**FINDINGS AND RECOMMENDATION
OFFICE OF PLANNING AND ZONING
ANNE ARUNDEL COUNTY, MARYLAND**

CASE NUMBER: 2025-0063-V

The applicants are requesting a variance to allow a dwelling with less setbacks than required with disturbance to slopes of 15% or greater and that does not comply with the designated location of a principal structure on a waterfront lot, and to allow an accessory structure (pool) with disturbance to slopes of 15% or greater on property located at 3260 Kitty Duvall Drive in Annapolis.

DEVELOPED CONDITIONS VARIANCE PLAN					
KITTY DUVAL ~ PARCEL 109					
3260 KITTY DUVALL DRIVE, ANNAPOLIS, MARYLAND 21403					
TAX ACCT. NO. 02-000-05037200					
TAX MAP	57	GRID	14	PARCEL	109
DISTRICT 2ND					
ANNE ARUNDEL COUNTY, MARYLAND					
SCALE: 1"=40'		DATE: 3/19/2025		PROJ. NO: KS03124	
				SHEET 2 OF 2

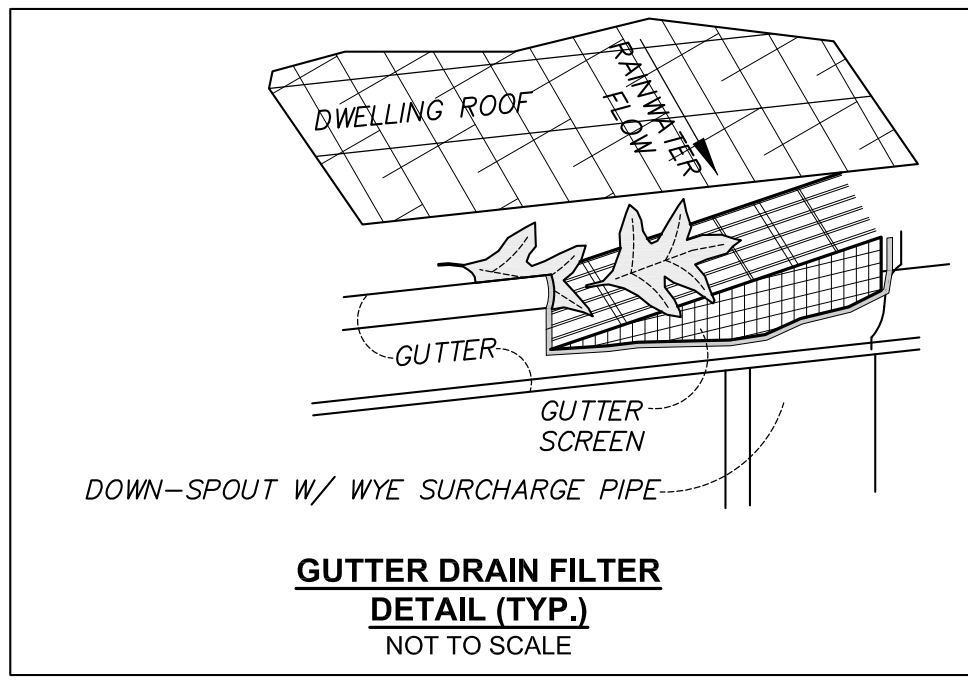
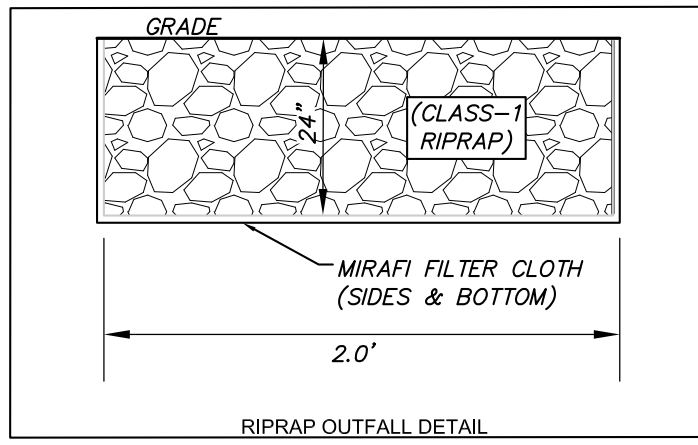
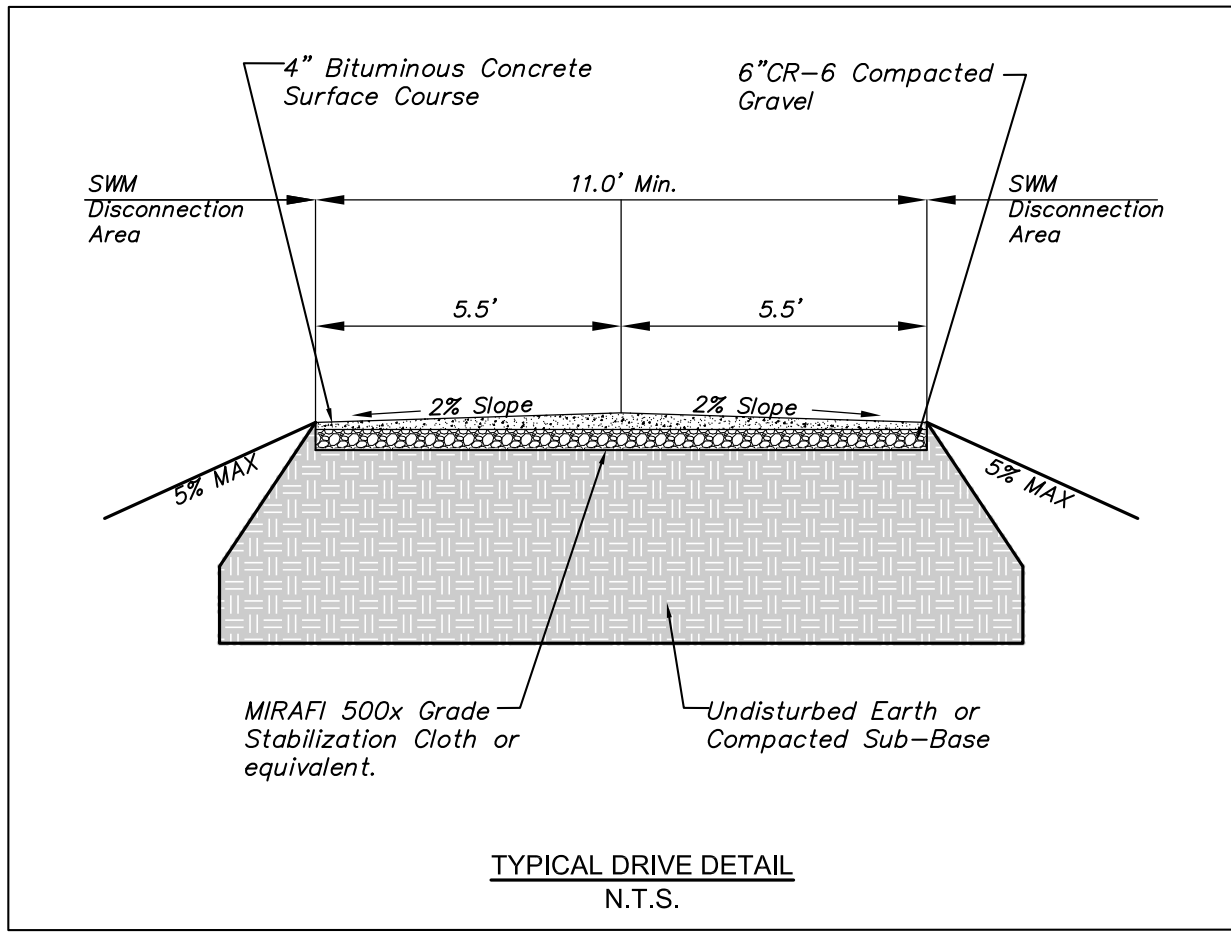
1. Is the existing well to be used or will a new well be drilled?
2. Provide the width and material of the proposed driveway.
3. If the driveway is to be treated by the northwestern micro-bioretenention, the front yard will need to be regraded, which can be completed at Grading Permit.
4. Geothermal wells are to have a 10' setback from any stormwater piping and roof drains.
5. Label the geothermal wells as either an open or closed loop system. If open, the geothermal wells are to have a 30' setback from any structures.
6. Geothermal wells are to have a 10' setback from any propane tanks. Note where, if any, above-ground or below-ground propane tanks are present on the site and neighboring properties.

Please verify the locations of all of the slopes 15% or greater. There are areas that appear to have been missed.

Please correct the legend as the symbols do not coincide with those used on the plan.

The steep slopes are not shown on the site plan depicting the proposed development so a complete evaluation cannot be completed. The layout and design of the structure however were not developed to avoid the steep slopes and in fact push the home further into the slopes. While it is recognized that the site is encumbered by environmental features, the home should be designed to avoid those features as much as possible.

1. On Sheet 1 of 2, for all structures, clearly label which structures are to remain and which are to be removed.
2. The Existing 15% Steep Slopes layer's hatch disappears when zoomed in, making it difficult to review the plans.

3. The steep slope buffer needs to extend not just along the eastern side (top) of the steep slopes but along the northern and southern portions. This would make the northernmost micro-bioretenention location within the steep slope buffer. SWMs cannot be installed within the steep slope buffers. They also cannot be installed within the 100-foot buffer.

4. Geothermal wells must have a 30-foot setback from a building's foundation. They are to also have a 15-foot setback from the 10' Ingress/Egress easement.

5. Geothermal wells need to be 50 feet from any source of contamination. Note where, if any, above-ground or below-ground propane tanks are present on the site and neighboring properties.

6. Per the Letter of Explanation, "the scope of the project will propose an 8" Sewer Main Extension with a standard cleanout." Expand the limits of disturbance to include the installation of the sewer main extension. At Grading Permit, a public utility easement and a Public Works Agreement will need to be required.

7. The LOD to the north of the easternmost micro-bioretenention is within the Kitty Duvall Drive ROW.
8. The easternmost micro-bioretenention must be 10 feet from the property line.

9. It appears there is plenty of open upland land allowing the house to be pulled out of the steep slope. This will be deferred to OPZ's Critical Area Team reviewer and/or OPZ's Zoning Administrator reviewer.

10. Is the existing well to be used or will a new well be drilled?

11. Label the contours correctly. Along the northern portion of the site the 6' contour is labeled as 9'.
12. At Grading Permit, the 10' Ingress/Egress easement will need to be expanded to include the neighbor's (3264/3266 Kitty Duvall Drive) existing driveway located on the property.
13. At Grading Permit, if the existing telephone and cable pedestals are not covered with an existing easement on the property, an easement(s) will be needed.

A **Pre-File** confirmation and recommendation was addressed by the Office of Planning and Zoning including input from Inspections and Permits. To clarify, the 15% and greater steep slopes have been accurately illustrated based on field run topographic survey. The existing steep slopes are delineated per the Critical Area Overlay criteria which defines steep slopes that are contiguous and a minimum 6-feet vertical. In addition, the height of the structure has been corrected to 35-feet.
